# SERVICE NO. 1194B

# BULLETIN

Date: April 12, 2012

**PERIODIC REPLACEMENT OF NOSE BAGGAGE  
DOOR COMPONENTS**

**FIGURE 1**

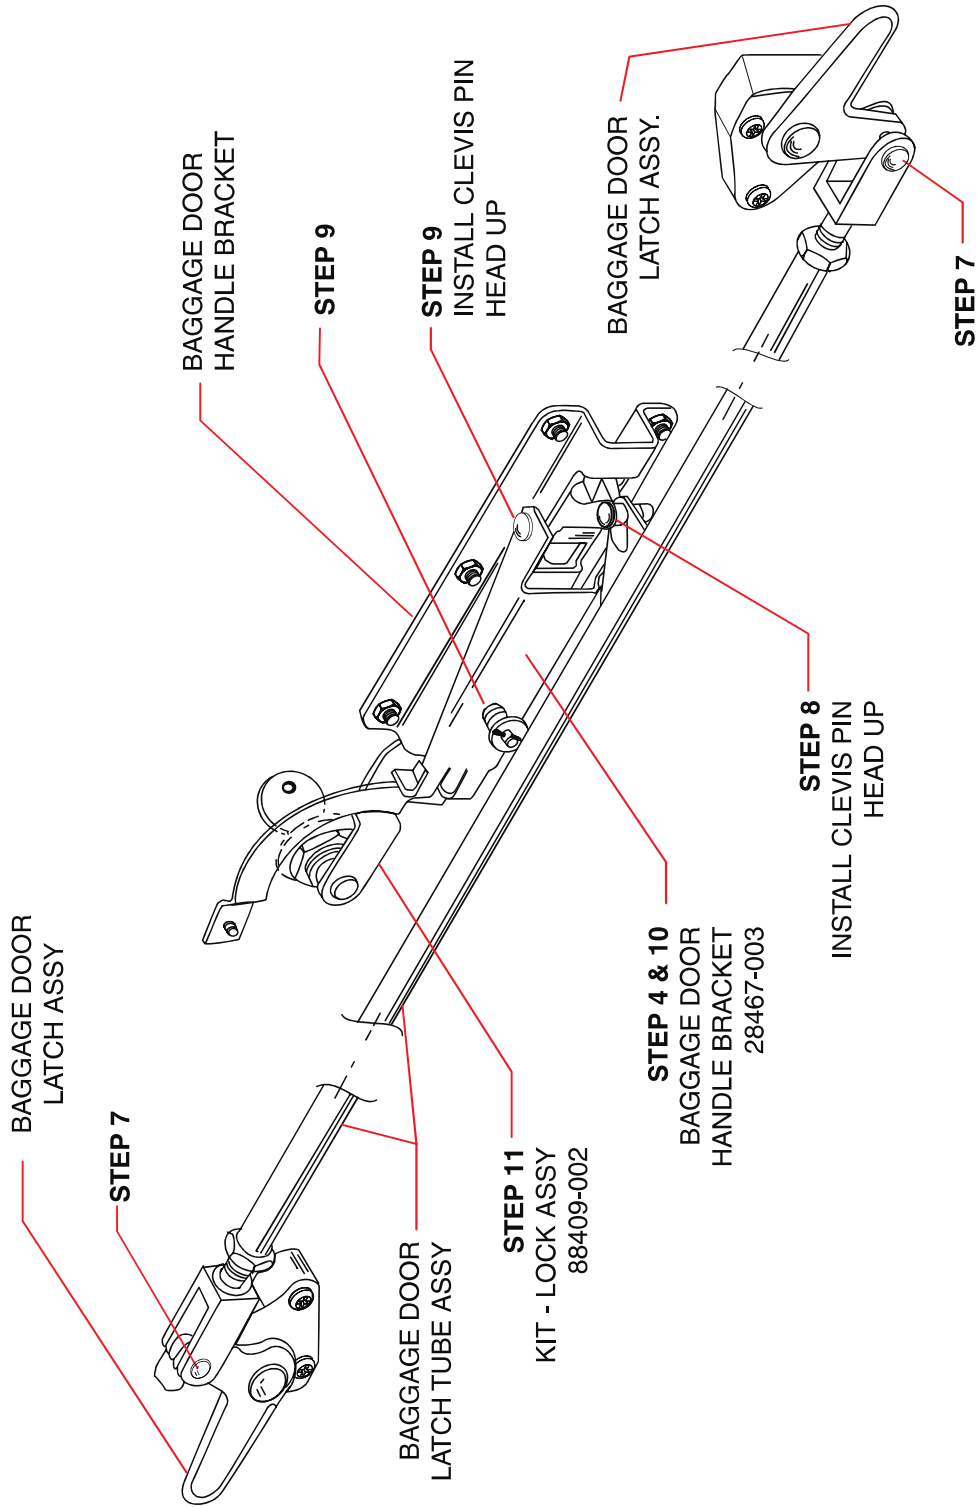
Refer to the appropriate Piper Illustrated Parts Catalog, Maintenance Manual, and Figure 1 of this Service Bulletin while performing the operations described below.

2. Remove nose baggage door from aircraft per Maintenance Manual instructions. Remove and discard existing clevis pins from the upper forward and aft door hinges.

6. Remove and discard springs common to BAGGAGE DOOR LATCH TUBE ASSEMBLY, as applicable. Refer to appropriate Illustrated Parts Catalog and Table 1, 2, or 3 for applicability and location. (Springs not shown in Figure 1.)
7. Remove and discard existing clevis pins that join the BAGGAGE DOOR LATCH TUBE ASSEMBLY to the forward and aft BAGGAGE DOOR LATCH ASSEMBLY.
8. Remove and discard existing clevis pin common to the BAGGAGE DOOR LATCH TUBE ASSEMBLY and the FORWARD BAGGAGE DOOR HANDLE.

FIGURE 2

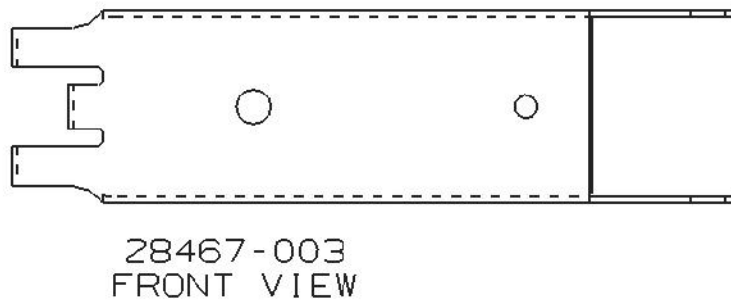
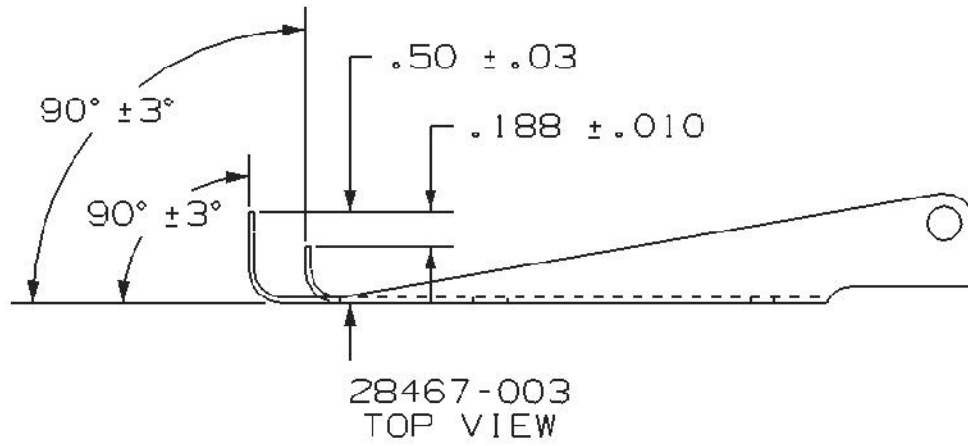
9. Remove and discard existing PINS (2 places) common to the BAGGAGE DOOR HANDLE BRACKET and the FORWARD BAGGAGE DOOR HANDLE.
10. Inspect the BAGGAGE DOOR HANDLE BRACKET, Piper part number 28467-003 for damage and replace on condition. Verify that the 28467-003 conforms to critical dimensions shown in Figure 2.
11. Remove and discard existing FORWARD BAGGAGE DOOR LOCK. Order and install KIT – LOCK ASSEMBLY, Piper part number 88409-002, one each.

Figure 3  
Door Latch Mechanism

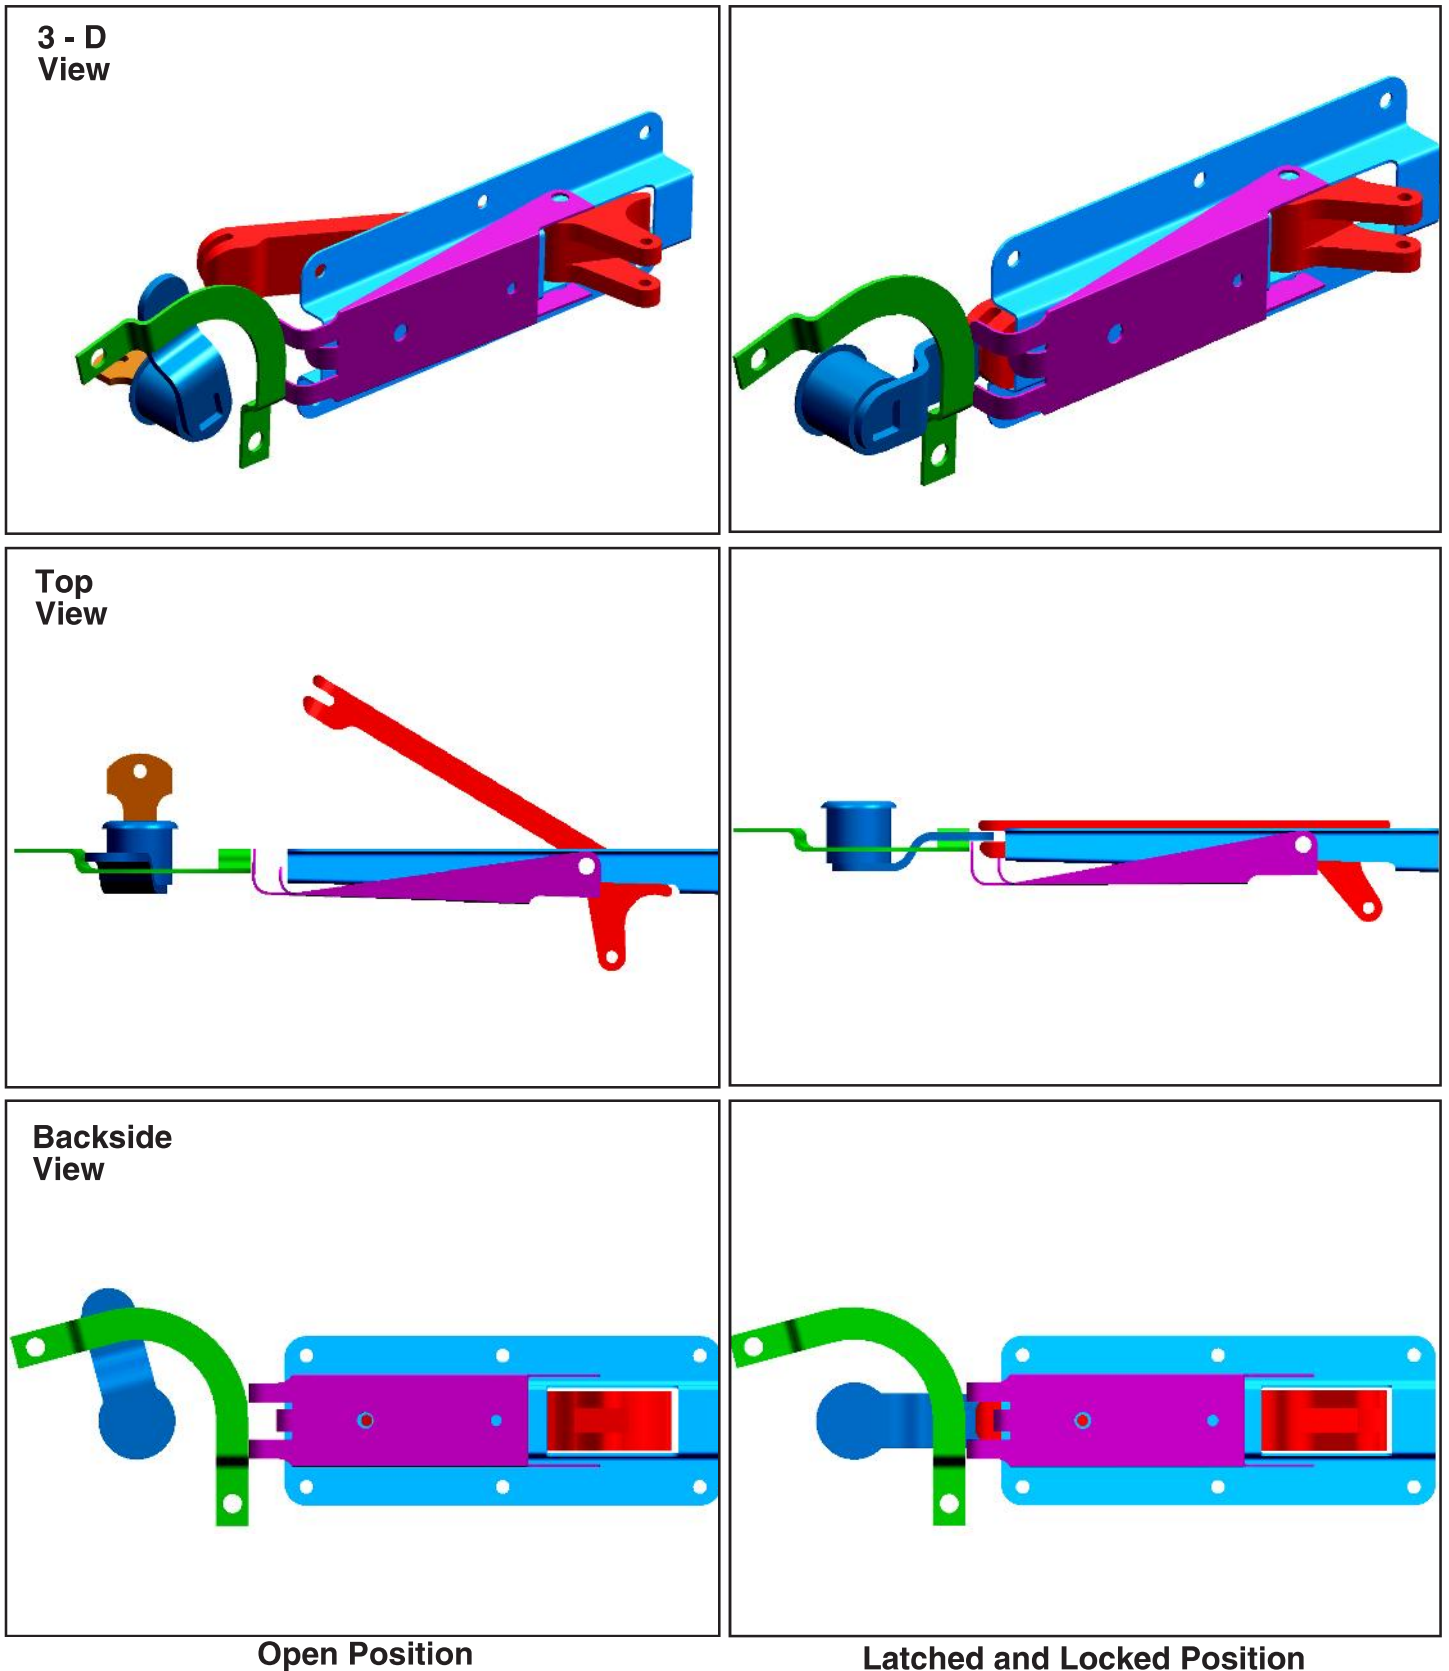
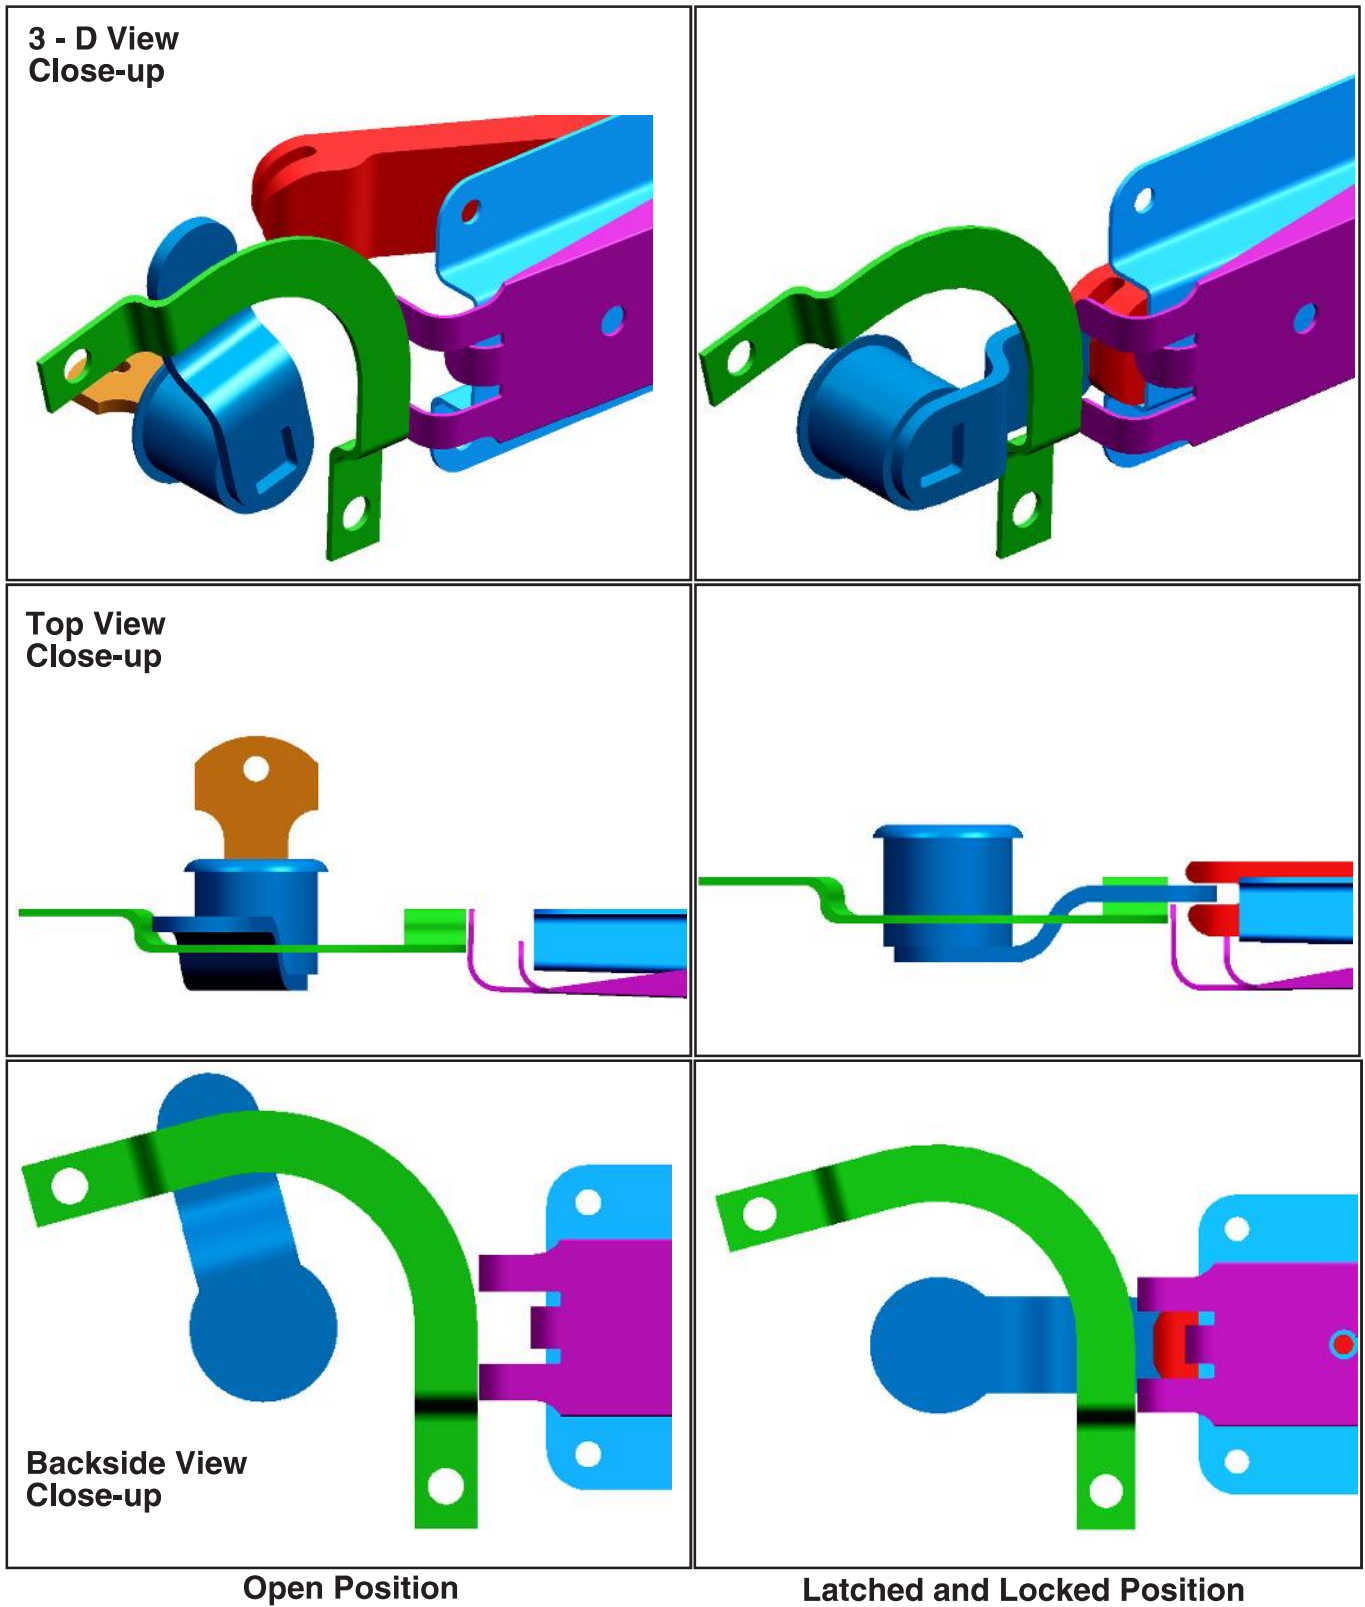
**NOTE:** Refer to Figures 3 and 4 for a visual depiction of the descriptions that follow.

The 28467-003 Bracket is hinged at the forward end with a clevis pin common to the Door Handle and the 30580-000 Baggage Door Handle Bracket, and features three right-angle prongs at the aft (key lock) end. In the locked position (i.e., prepared for flight), the middle prong exerts contact pressure against the Door Handle (due to compression force from the coil spring which is mounted on the back of the 28467-003 Bracket), holding the adjacent upper and lower prongs inboard, clear from contact with the locking cam.

Normal opening sequence is as follows: A key is inserted into the key lock and turned, rotating the locking cam out of the slot in the Door Handle. When the key is rotated beyond approximately 40 degrees from the locked position, the coil spring acts to push the aft end of both the 28467-003 Bracket and the Door Handle outboard (open), by a distance of approximately one quarter (1/4) inch. With the 28467-003 Bracket in this outboard position, the upper prong now blocks the return path of the locking cam, preventing the locking cam from rotating back into the locked position unless the handle is pushed back into the fully latched position (thereby preventing the condition described in SB604A, noted above).

As part of the normal door closing sequence, the aft end (nearest the key lock) of the Door Handle is pressed flush with the surface of the outer door. This action causes contact pressure between the Door Handle and the middle prong of the 28467-003 Baggage Door Handle Bracket. Both parts rotate together on a common hinge line, compressing the spring, and moving the upper prong inboard, out of the path of the locking cam.

With the Door Handle held flush as described above, the key may then be turned to the locked position, engaging the locking cam into the slot in the Door Handle. With the locking cam in the locked position, removal of the key prevents rotation of the locking cam, which in turn prevents the door handle from opening.

Figure 5

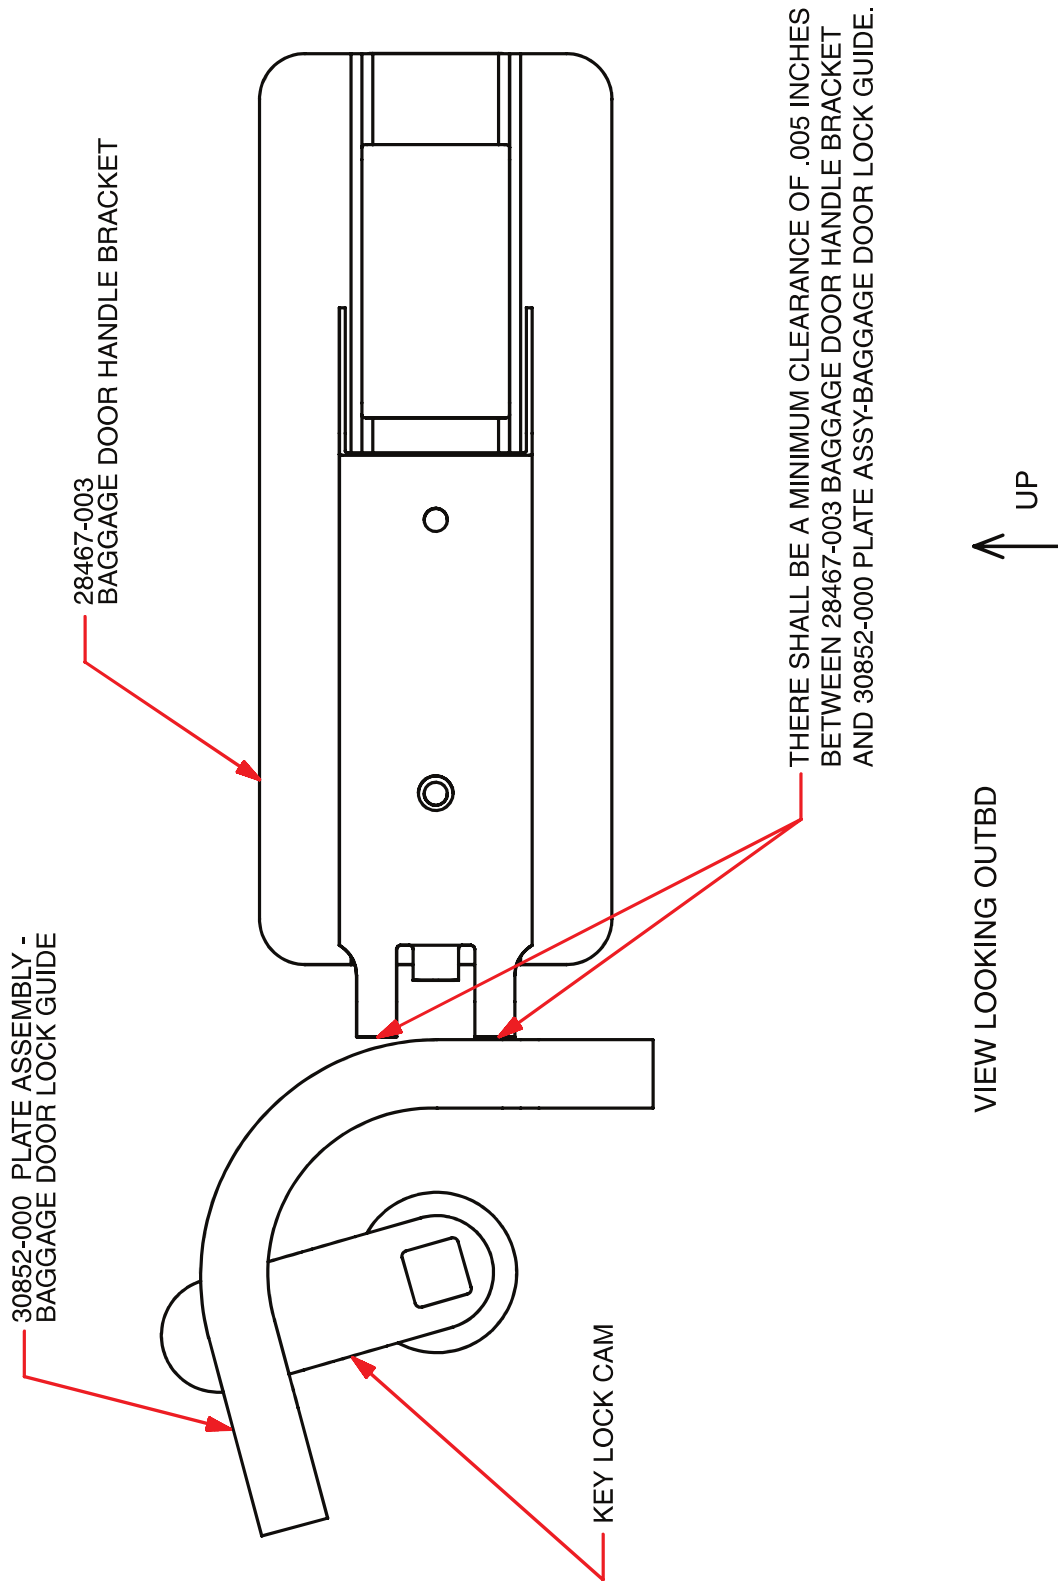
5. With the 28467-003 BAGGAGE DOOR HANDLE BRACKET installed, verify that a .005 inch minimum gap exists between this part and the 30852-000 PLATE ASSEMBLY – BAGGAGE DOOR LOCK GUIDE, as shown in Figure 5. This positive clearance must exist during the entire latching and locking sequence.

- If these two parts maintain a clearance of .005 inches or more during the entire door latching and locking sequence, no rework is required.
- If these two parts cannot maintain a clearance of .005 inches or more during the entire door latching and locking sequence as currently installed, or if contact occurs between these parts, relocate the factory-installed 30852-000 PLATE ASSEMBLY – BAGGAGE DOOR LOCK GUIDE as follows:
